SEWAGE DISPOSAL SYSTEM

MARYLAND STATE DEPARTMENT OF HEALTH*

HOWARD COUNTY

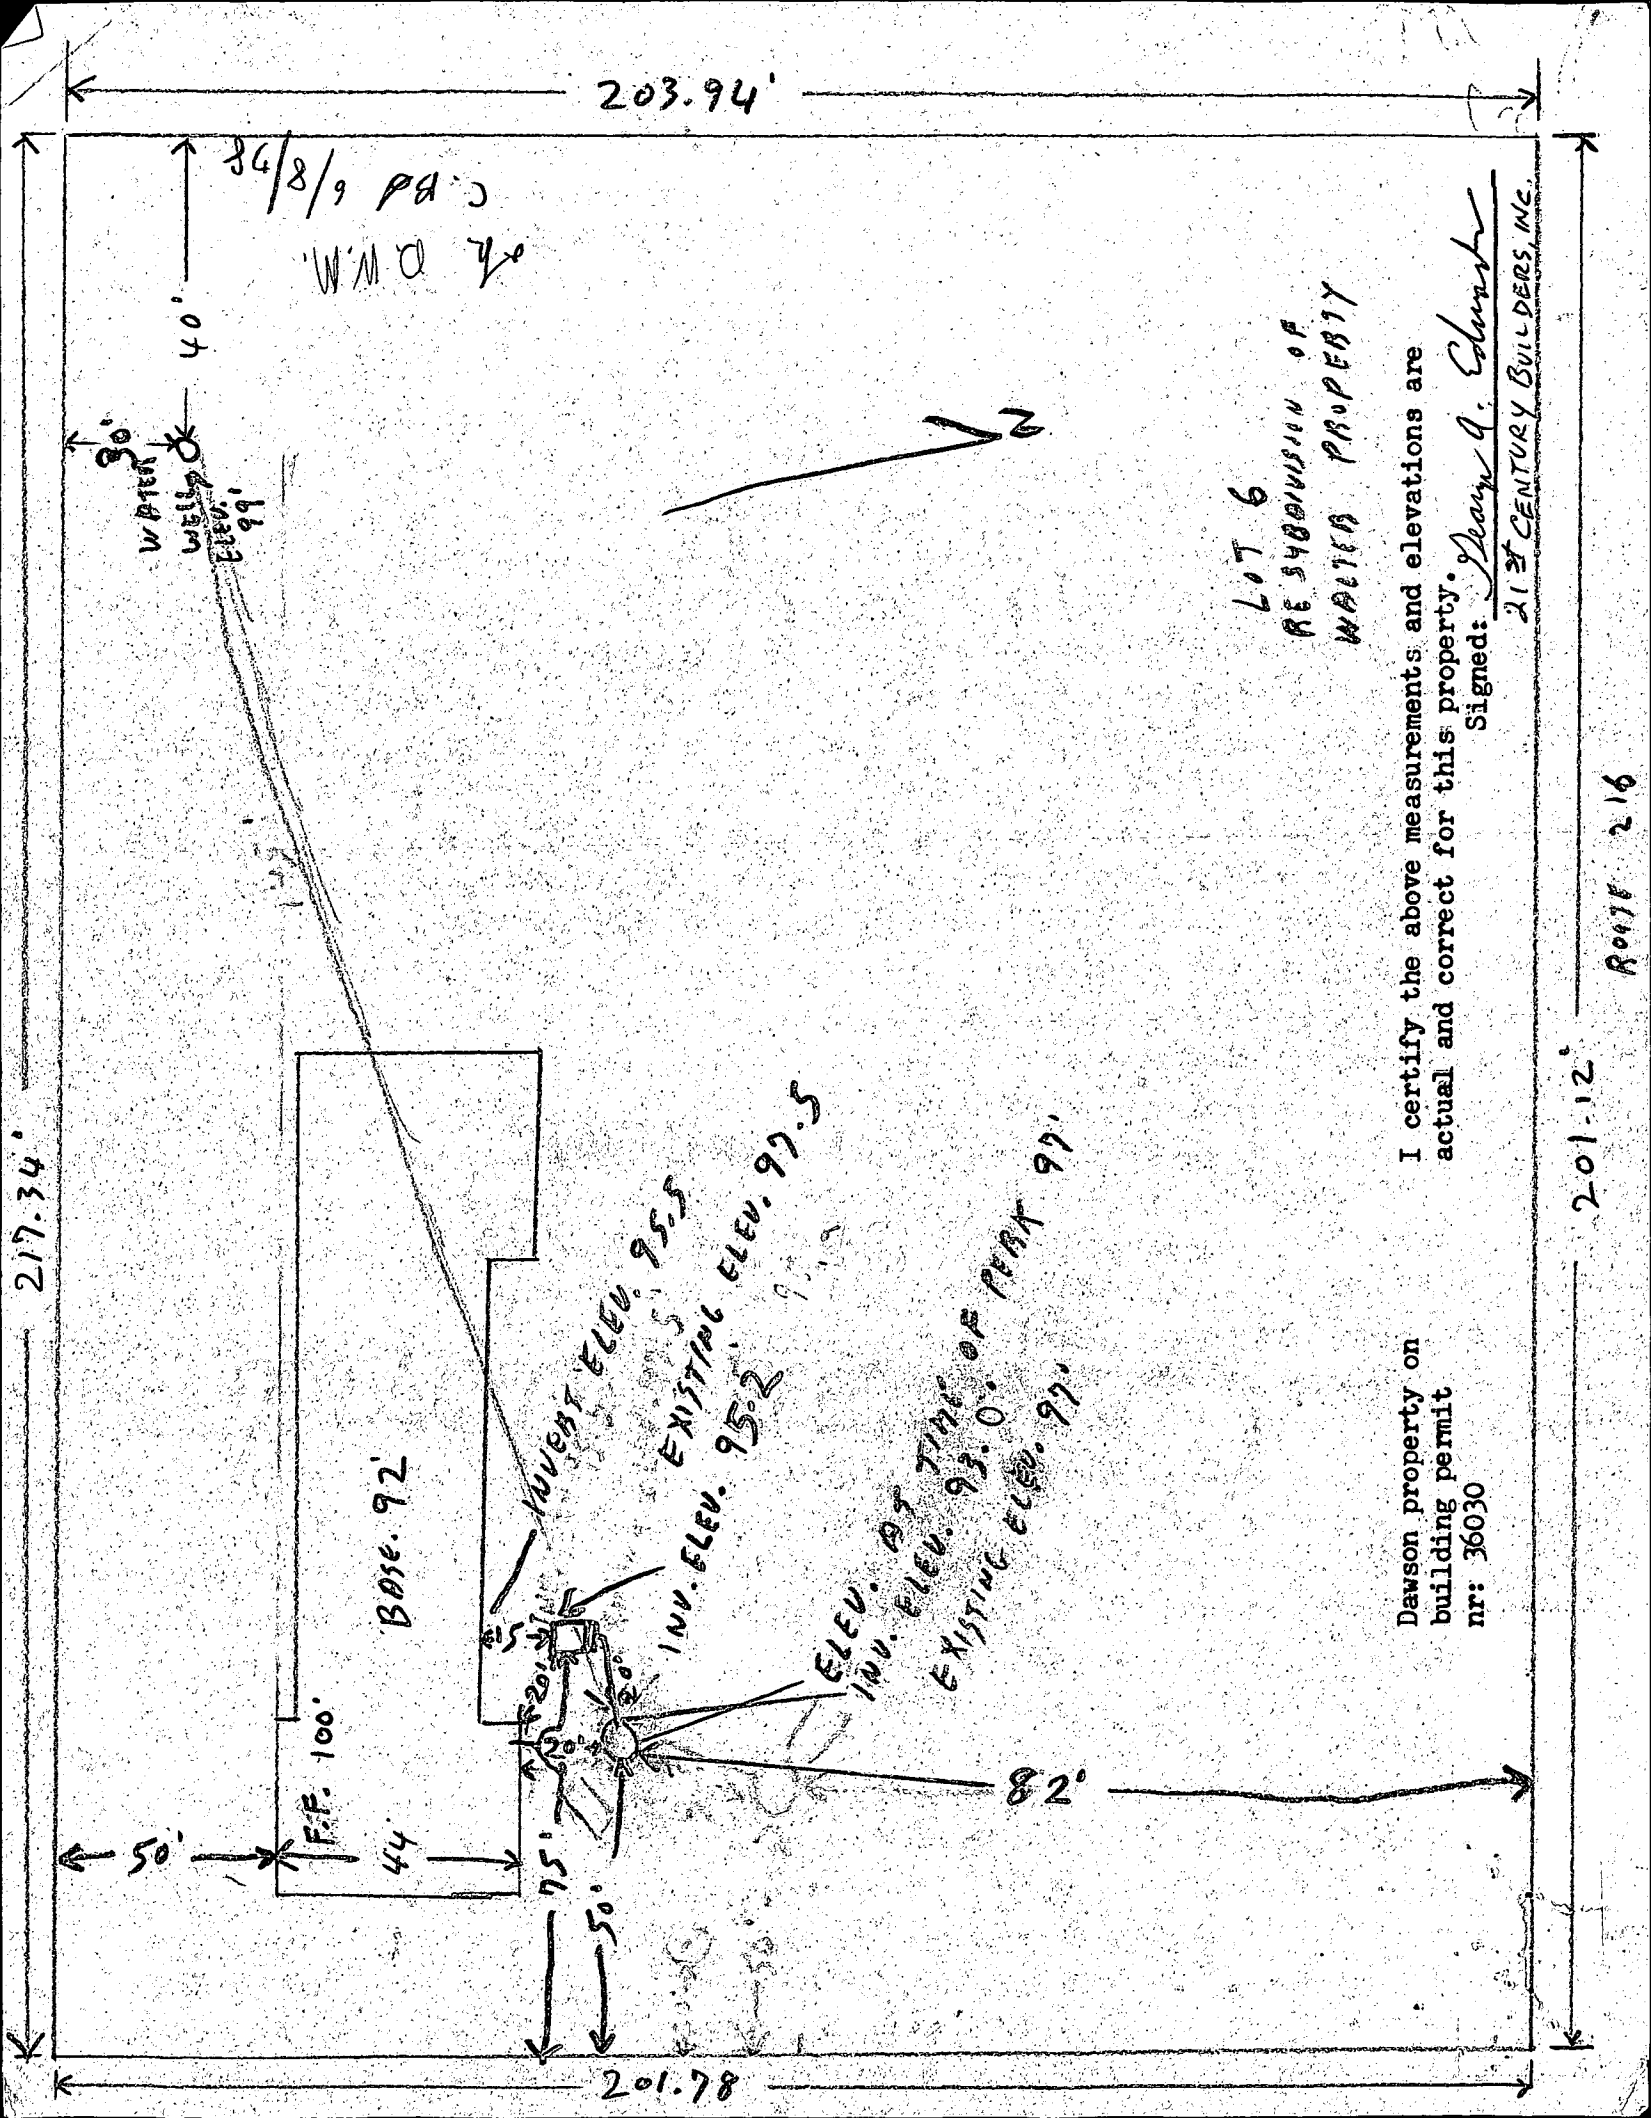
REMARKS 28 Dec 78 - Bldg. Permits indicates 4 BR dwelling. Short on area by 154 ft²; Effective depth begins at 5'. Call for next inspection when trench is excavated. Trench will be 25' long, 2' wide, 12' deep & be directed toward right prop line AS seen from road. (GLK)
28 Dec 78 - Hold for supervision 3BR system for 4BR house. (GLK) 29 Dec 78 - Talked to Sadler who stated that dwelling has 3BR. (GLK) See attached sheet. (GLK)
